Technical Service Bulletin

Tennant 6600 - Serial numbers 025000 and above (Only 1.6 GM Gasoline and LPG machines equipped with IMPCO/Spectrum engine management systems)

SUBJECT:

The wire harness on IMPCO/Spectrum controlled machines should not be attached to the ENGINE OIL PRESSURE LIGHT. Only machines equipped with the ZEEMS engine management system (serial numbers below 025000) or diesel engines have the wire harness attached to the ENGINE OIL PRESSURE LIGHT.

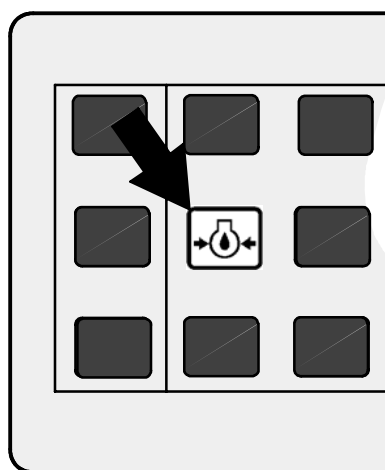
If servicing a 6600 machine above serial number 025000 equipped with the IMPCO/Spectrum engine management system, ensure the 8/GRY and 27/PUR wires from the main wire harness are not attached to the ENGINE OIL PRESSURE LIGHT.

FIG. 1

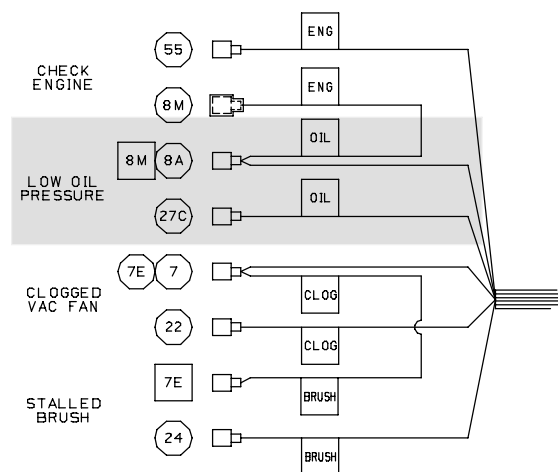
1. Observe the back of the instrument panel. The 8A/GRY and 27C/PUR wires from the main wire harness should not be connected to the ENGINE OIL PRESSURE LIGHT. Refer to Fig. 1 and Fig. 2.
2. If the 8A/GRY and 27C/PUR wires are connected to the ENGINE OIL PRESSURE LIGHT, disconnect the wires from the light, tape the wires to prevent them from grounding, and use tape or a cable tie to secure the wires back to the harness.

The 8A/GRY and 27C/PUR wires from the main wire harness **must not** be connected to the Engine Oil Pressure Light. Refer to Fig. 2 for a schematic.
